10/1/89

Telephone conversation with Mr P. Shields (B.S.)
regarding thermacot

Regulator.

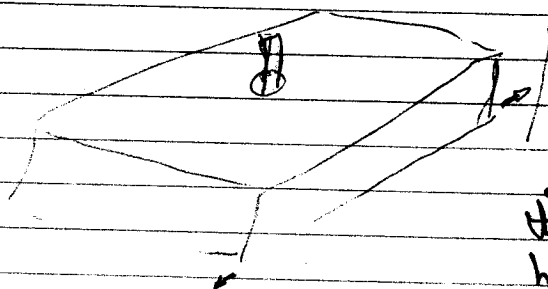
Large 100uf cap too close to top cover therefore
requires insulating strip on top cover.

Creepage of L and N connections on P.C.B too close
to casing sides therefore insulation required on sides
of casing.

if creepage from open ends
of regulator are less than 4mm
then insulation is required of
head casing.
